Sinclair College
Building 14 – EMS Classrooms & Sim Lab
FAC 24-28X
Dayton, OH

ADDENDUM 01

Date of Addendum: January 31, 2025

This addendum consists of five (5) pages plus attachments.

LOWER LEVEL
FLOOR PLAN - NEW WORK

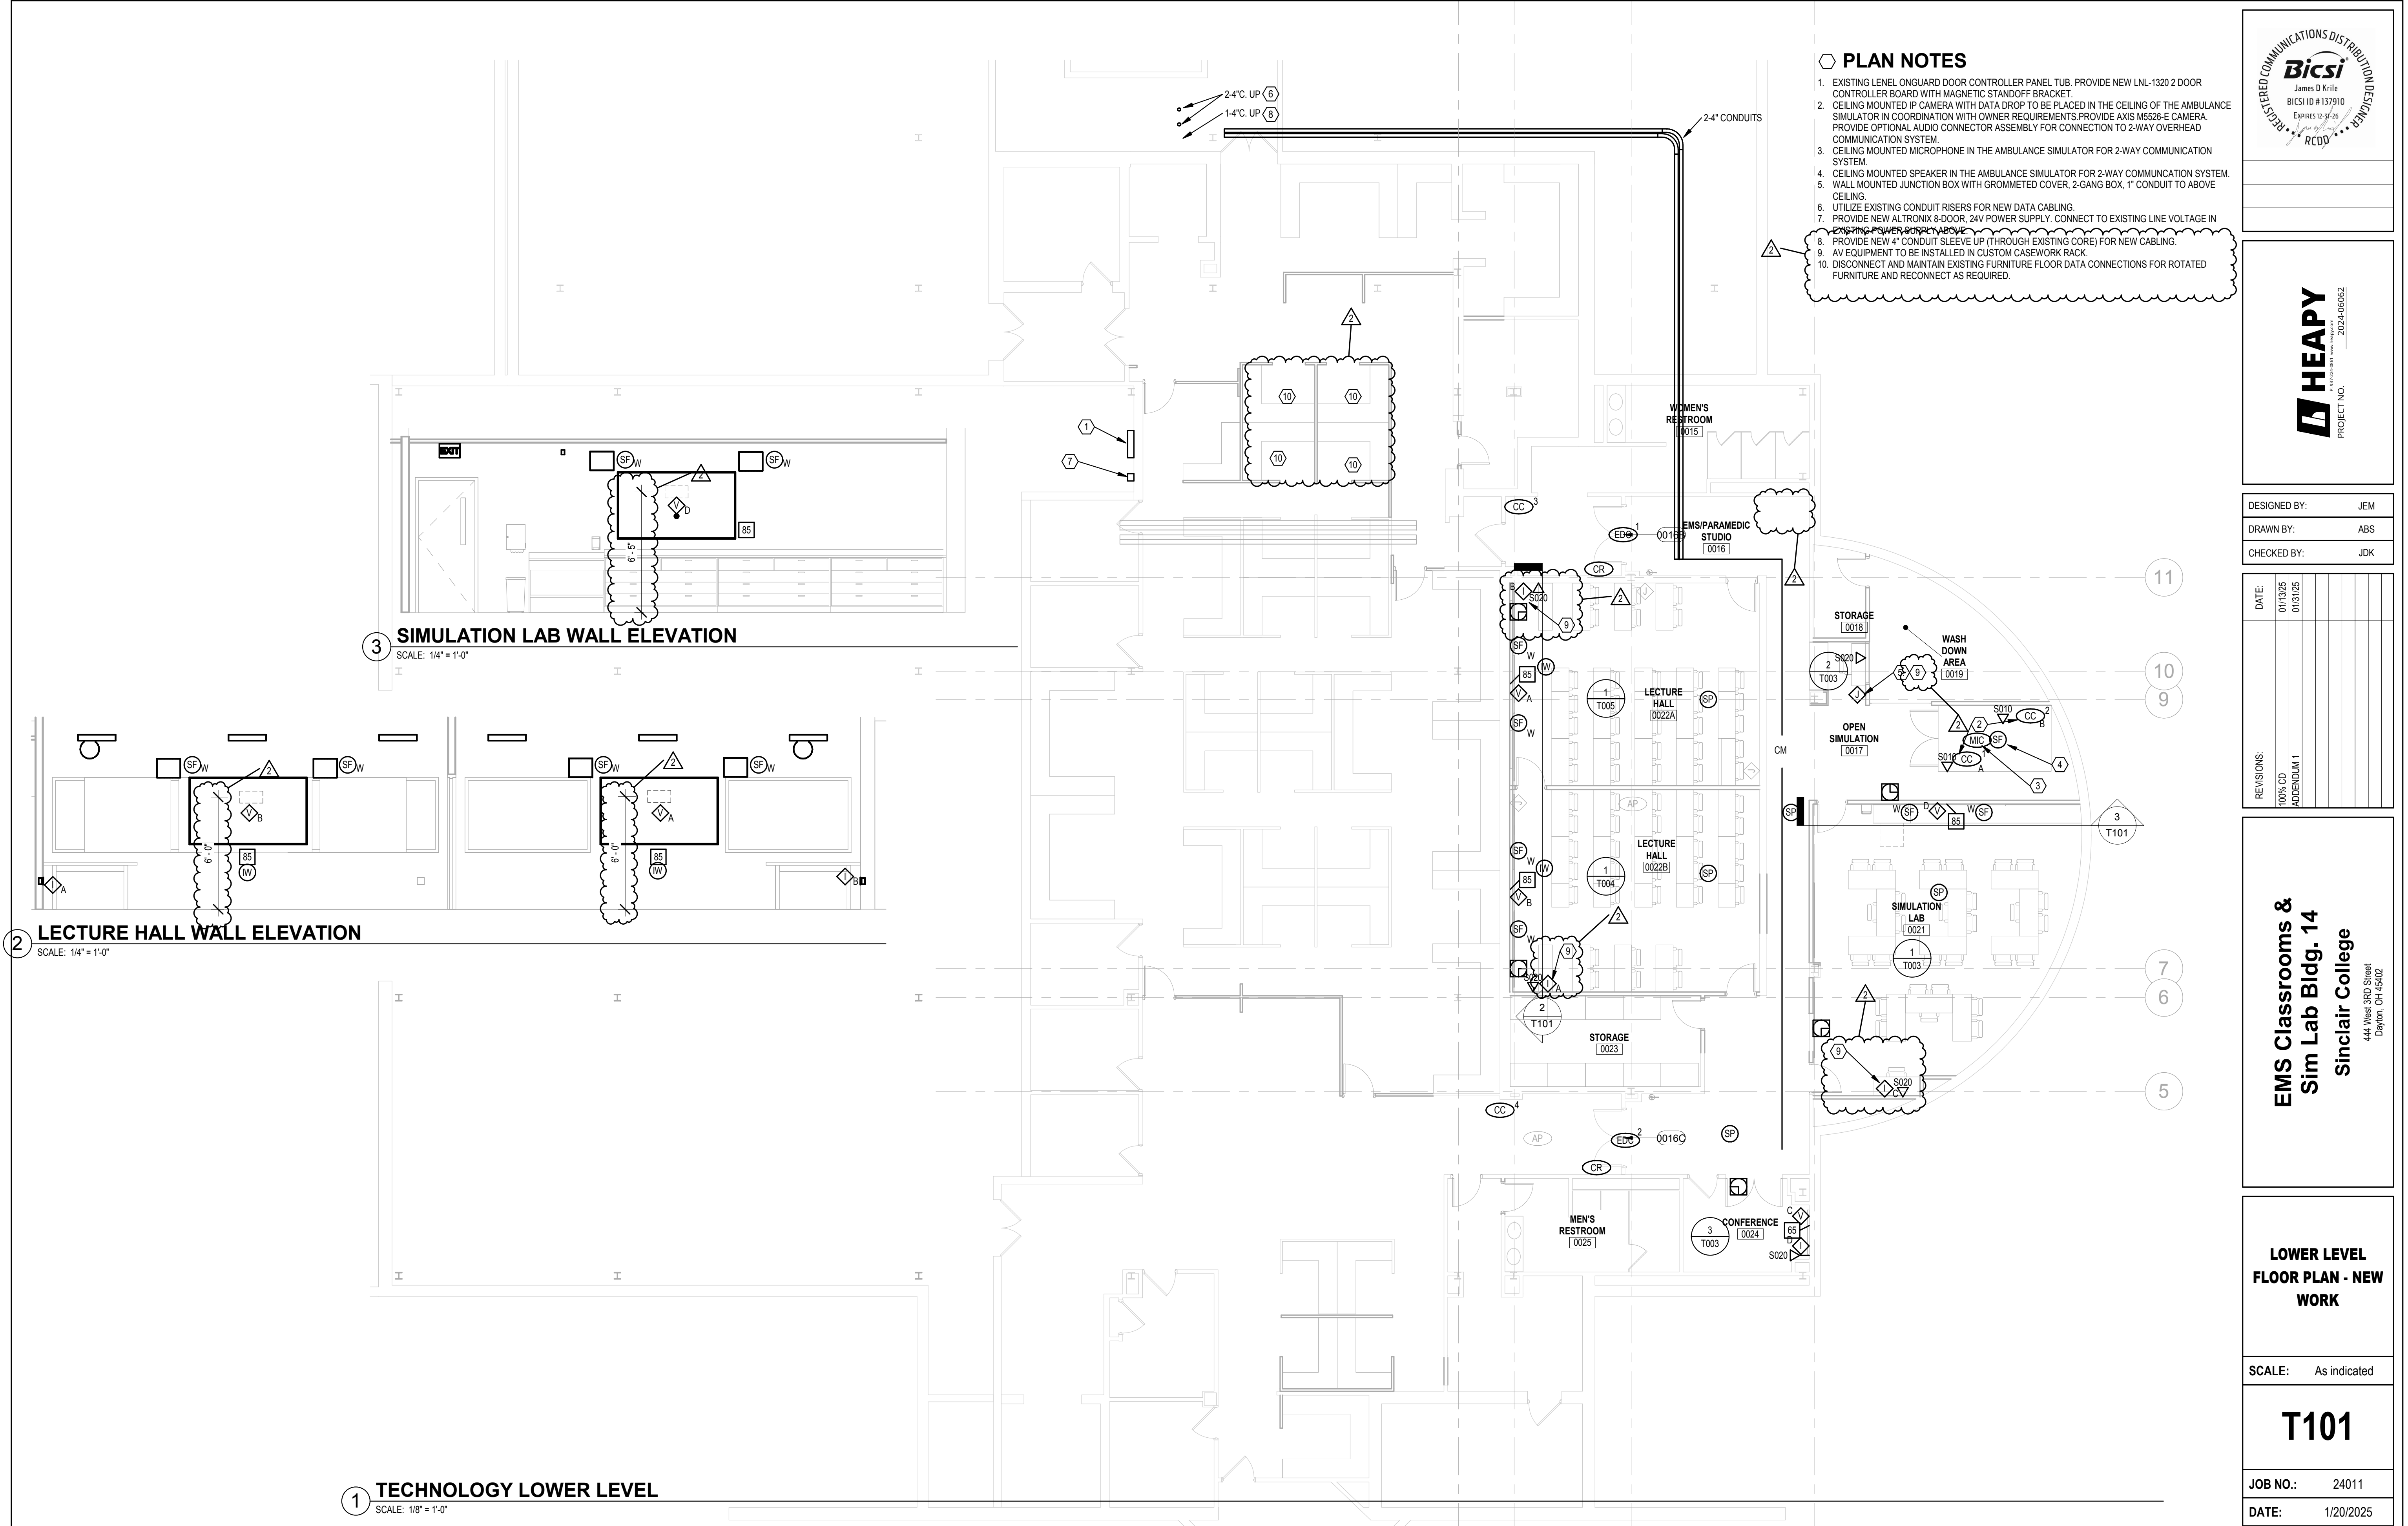
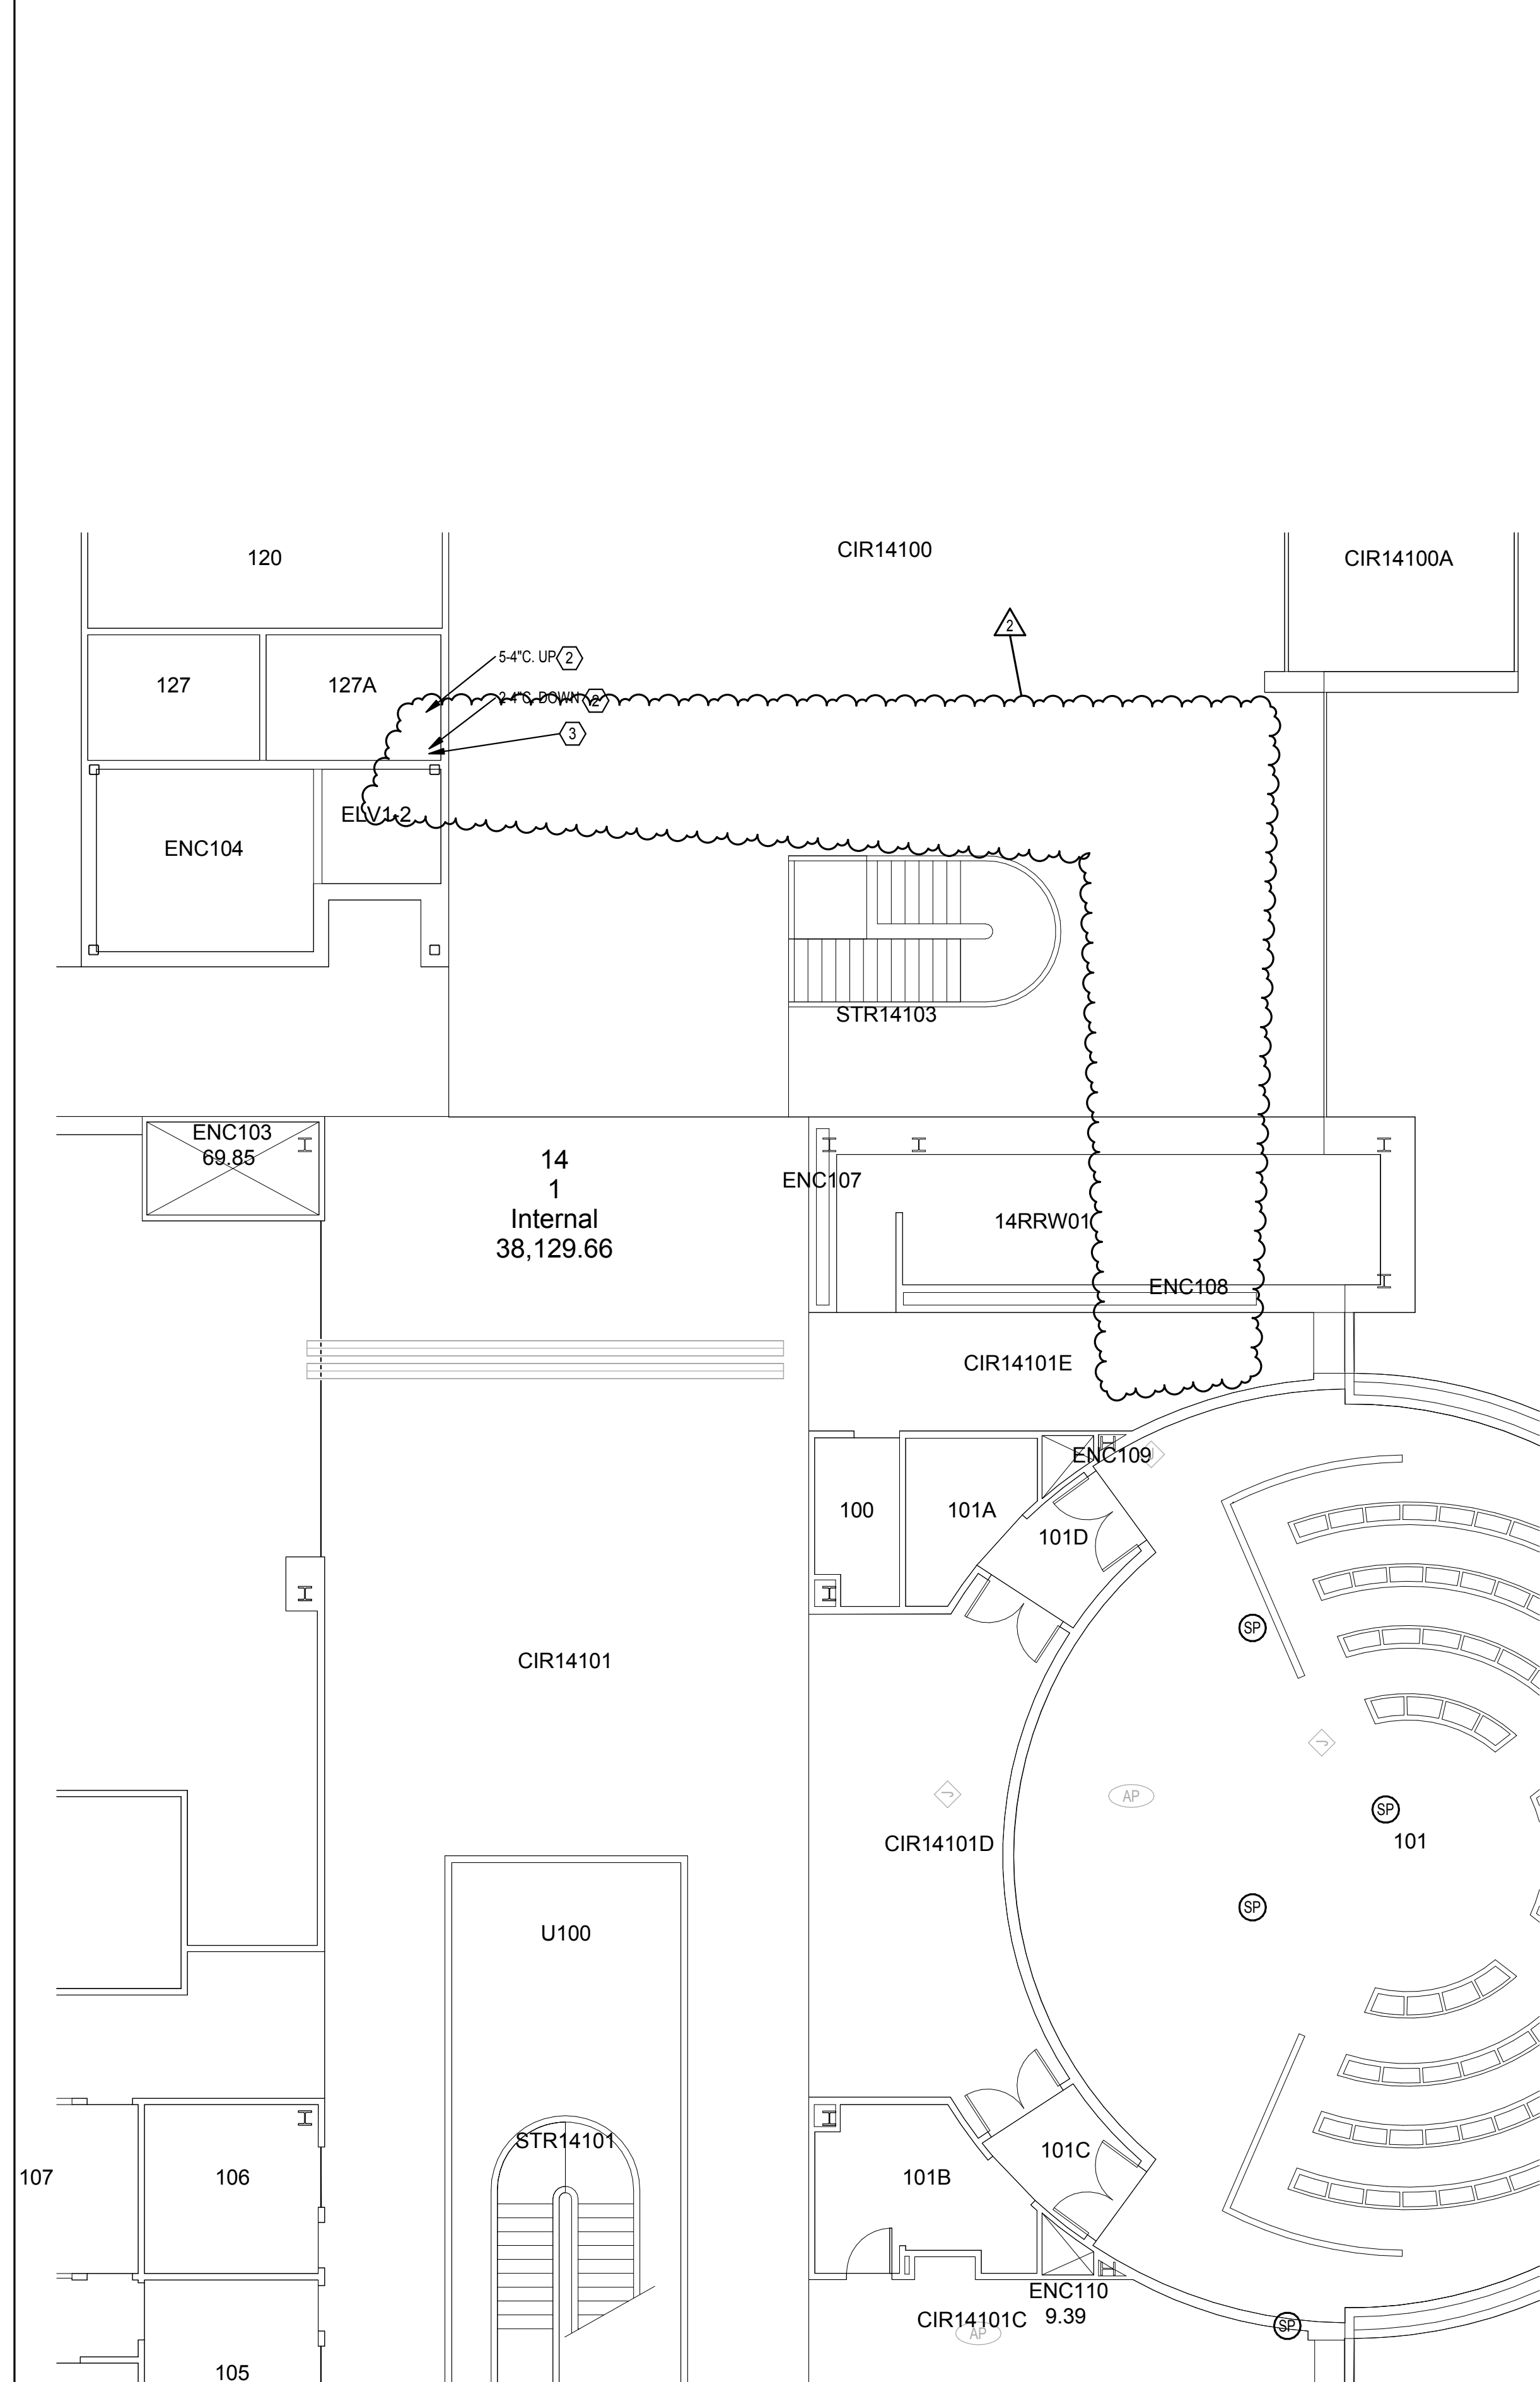
16. Sheet T101 LOWER LEVEL FLOOR PLAN

- a. Add plan note 10 to revised existing cubicles.
- b. Add flat panel outlet box mounting height detail to wall elevations
- c. Add plan note 9 to instructor furniture location.
- d. Remove ceiling mount camera in EMS/PARAMEDIC STUDIO 016

FIRST AND SECOND FLOOR PARTIAL PLANS

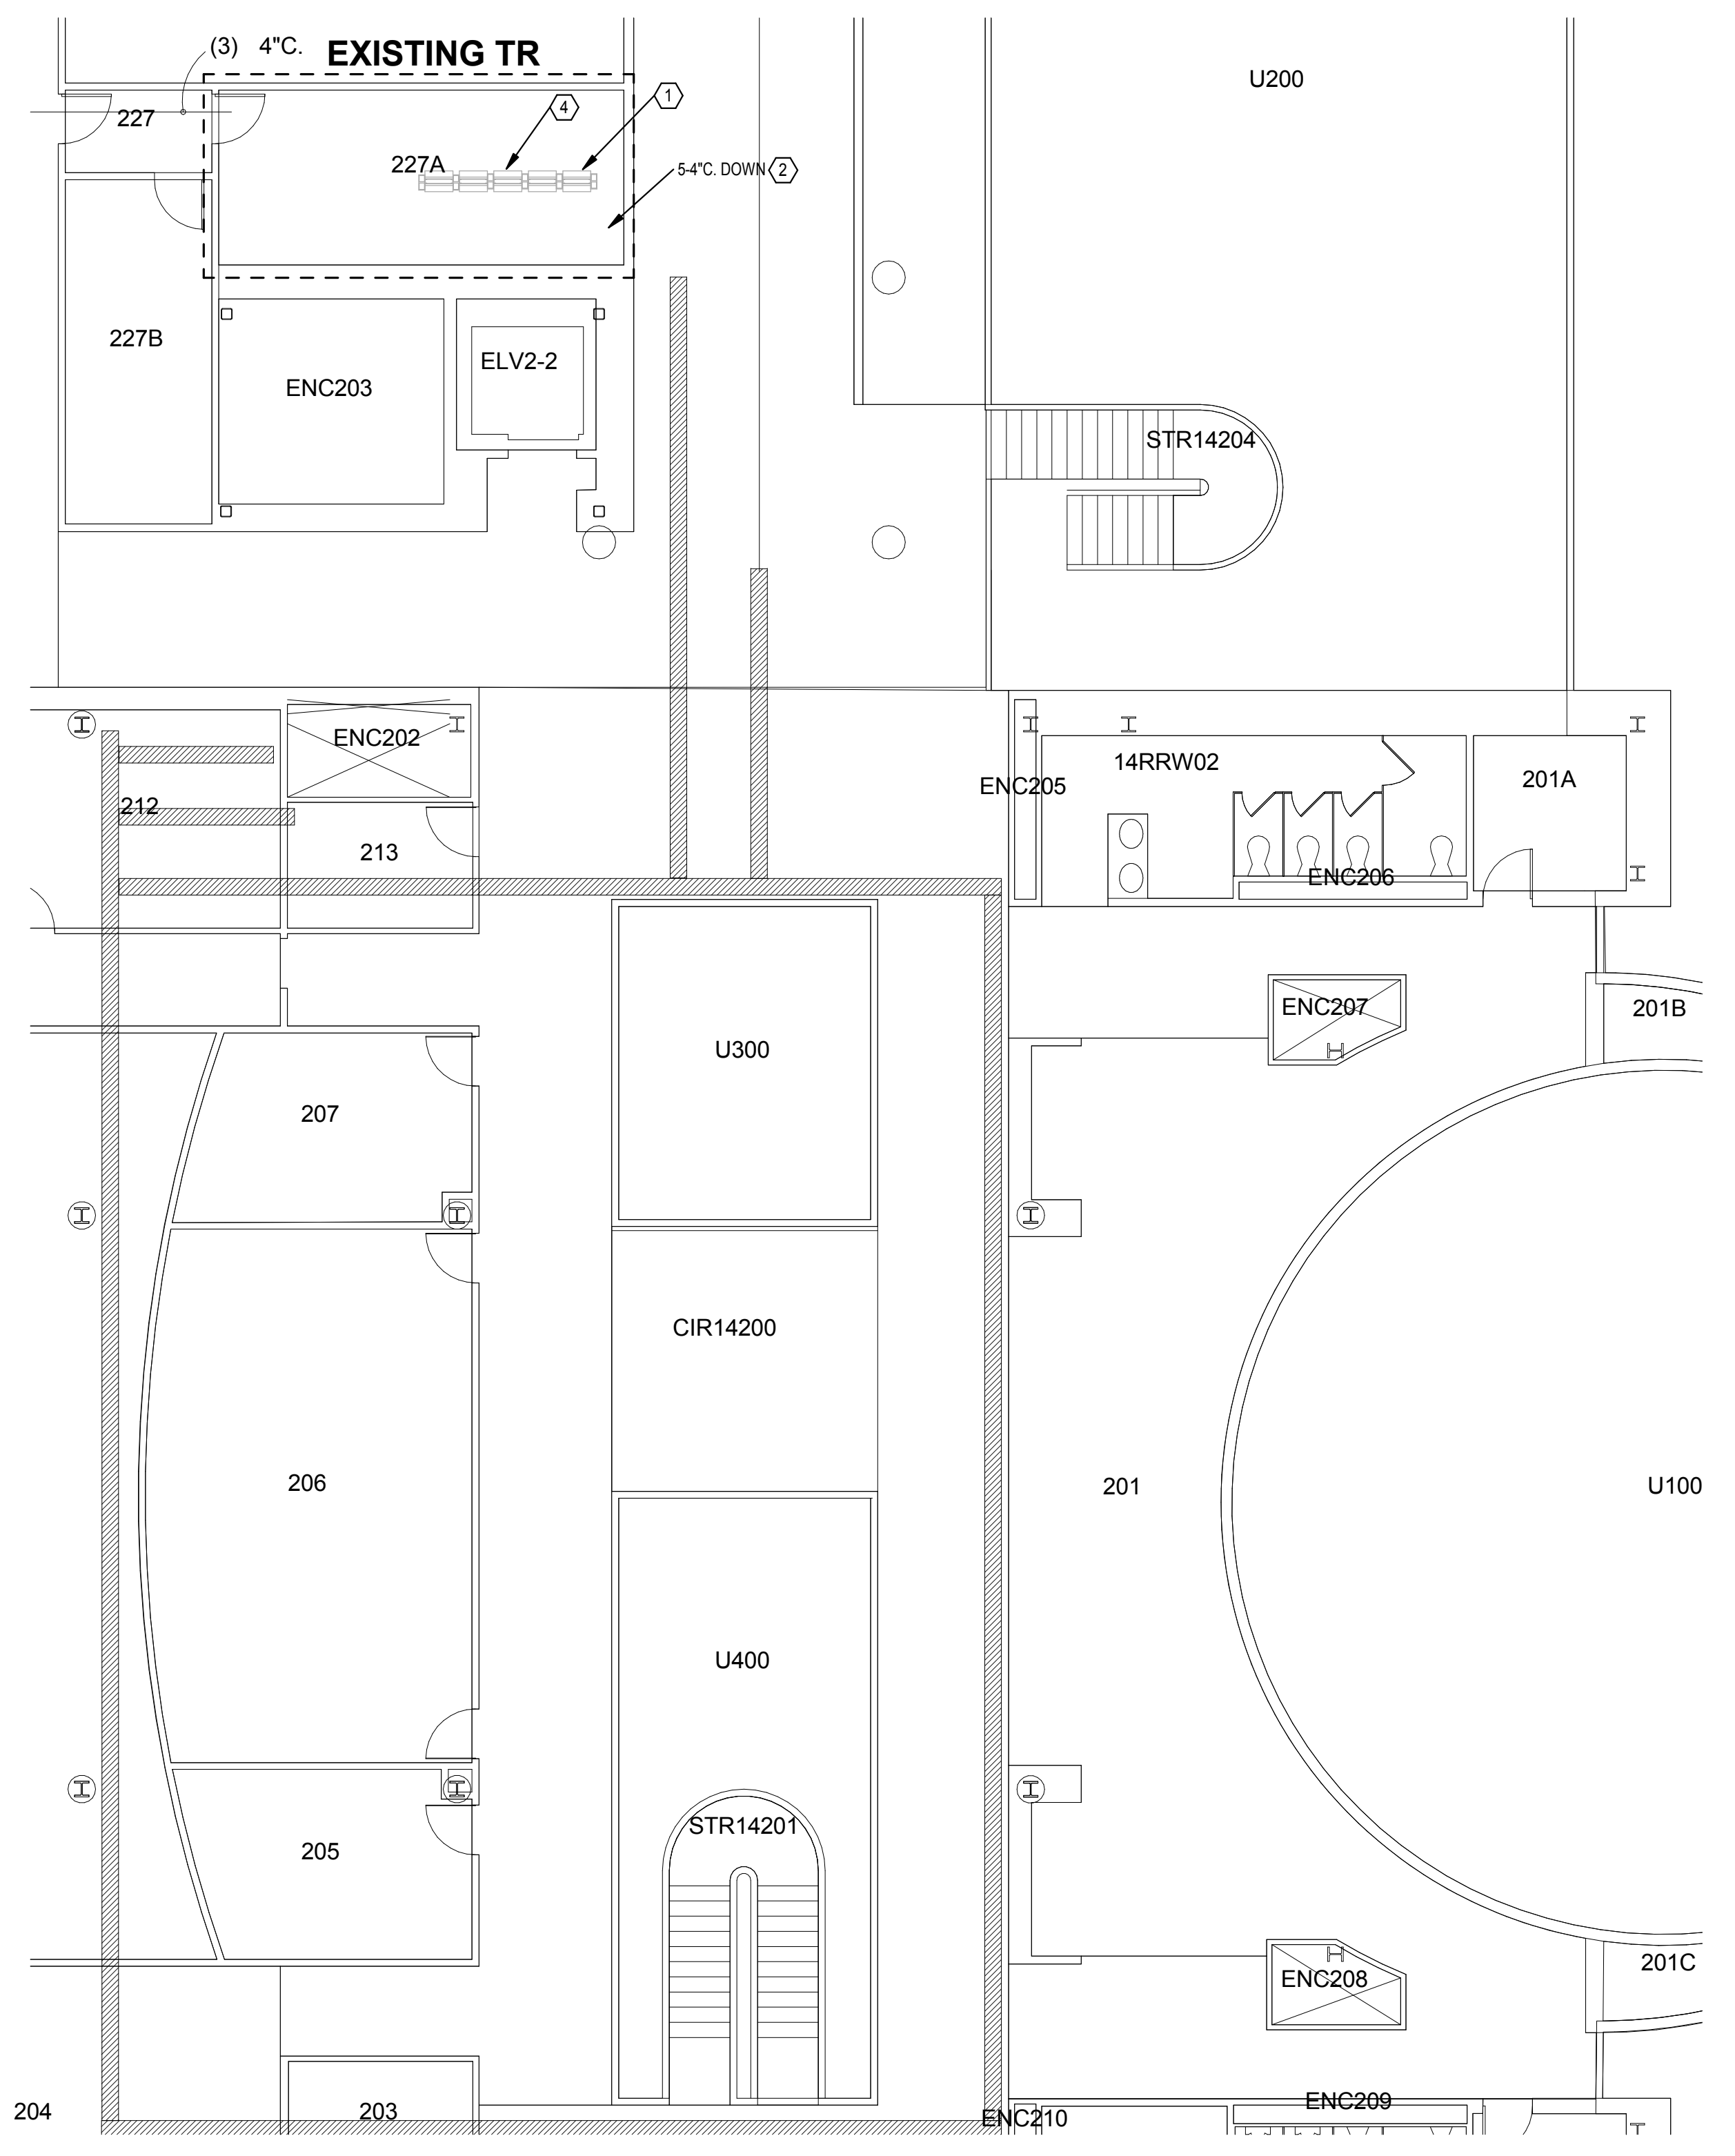
17. Sheet T102 FIRST AND SECOND FLOOR PARTIAL PLANS

- a. Remove 4” conduit pathway duplicated on the first floor.
